## ANN ARBOR HISTORIC DISTRICT COMMISSION

### Staff Report

**ADDRESS:** 1127 W Huron Street, Application Number HDC19-146

**APPLICATION:** The applicant seeks HDC approval to add a 32" x 57" egress window in a new opening with a 62" deep molded polyethylene well, on the rear elevation.

**2062 MODEL WELLCRAFT  
WELL SYSTEM**

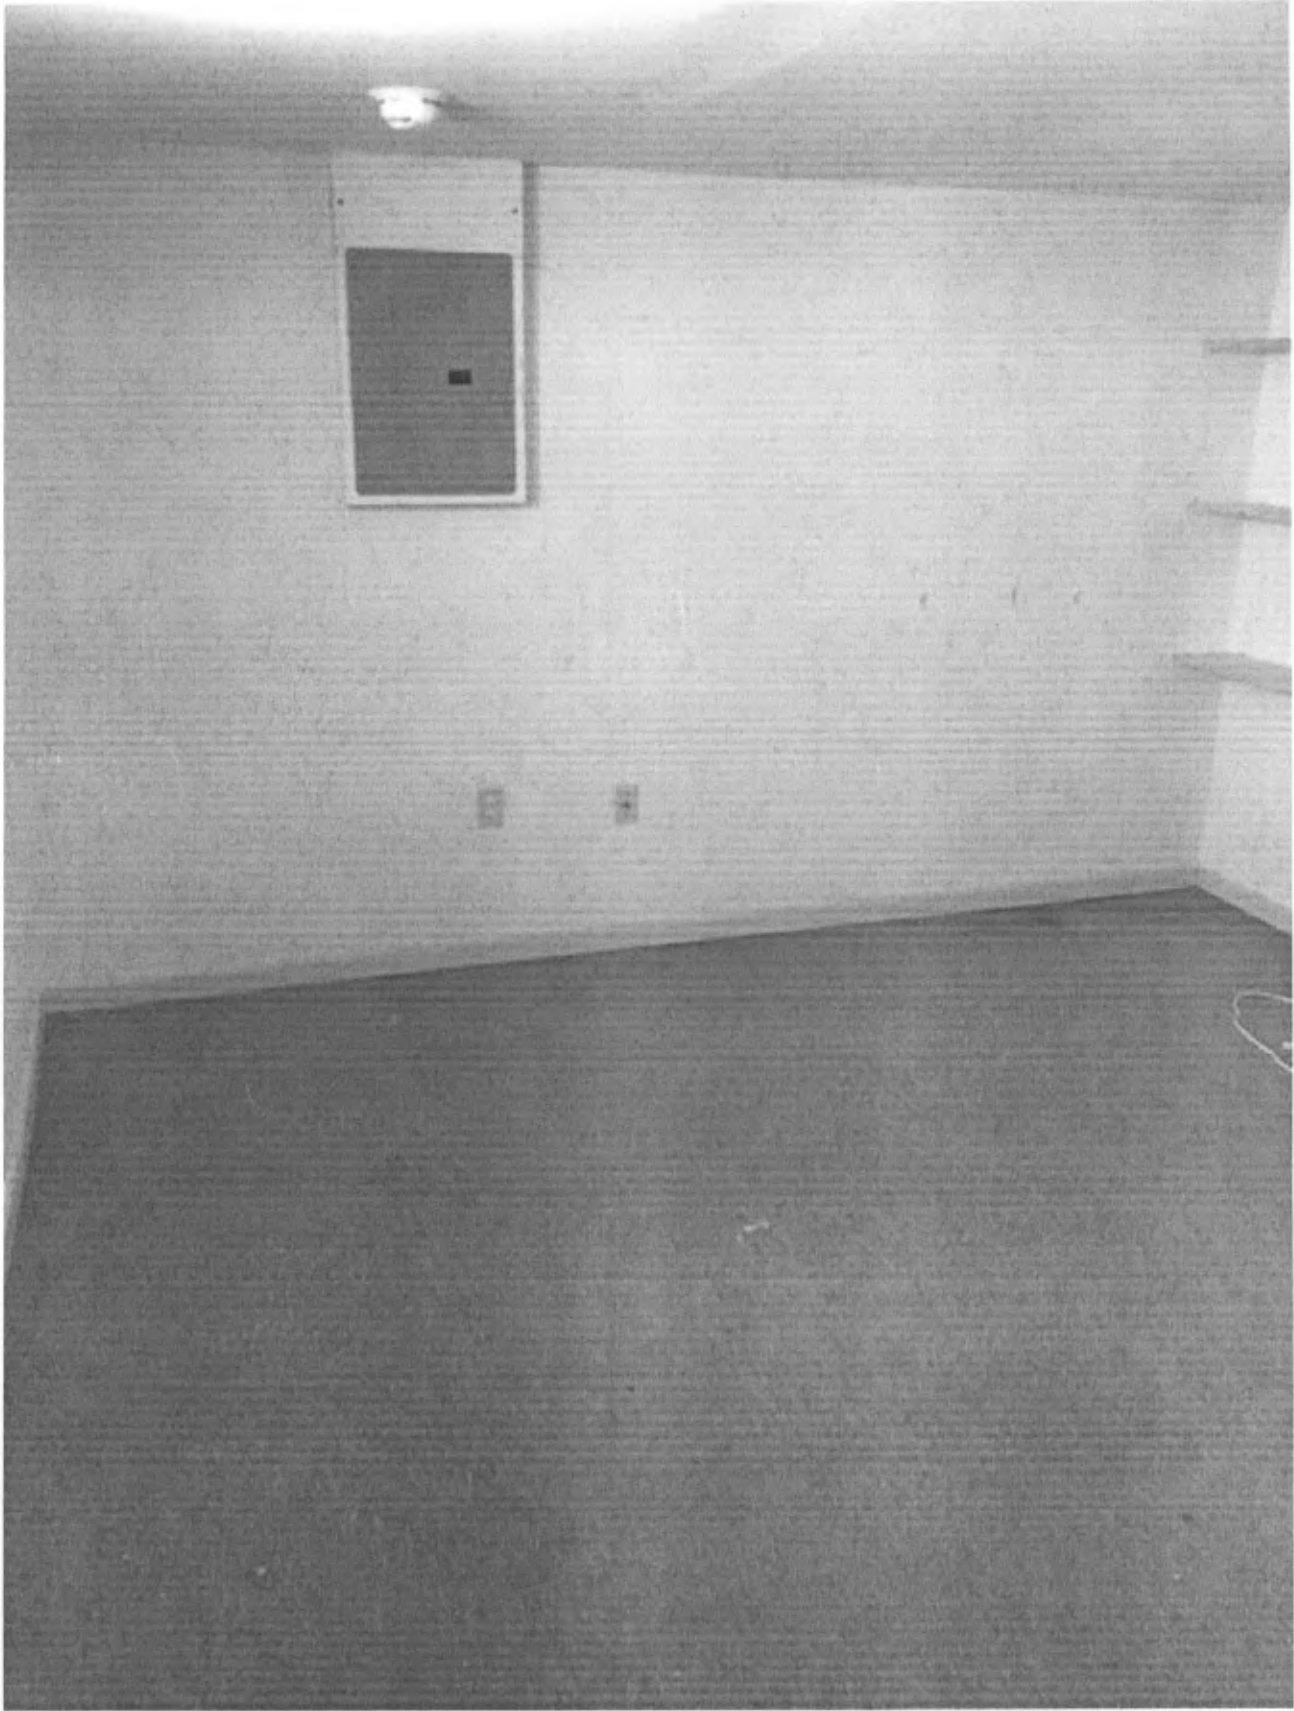
2. The well is a prefabricated polyethylene unit with built in steps. It extends a few inches above grade in a U shape, and is 62" deep. A section drawing and plan views are provided. The horizontal depth of the well is not provided, but appears to be about 35". No cover is listed as part of the application. The vinyl egress window is 32" wide by 57" tall, and swings in. Detail is provided for the window and well.
3. Staff believes the well is appropriate since it is not visible from the street and meets the *Standards and Guidelines*. No character-defining features of the house are impacted by the proposal.
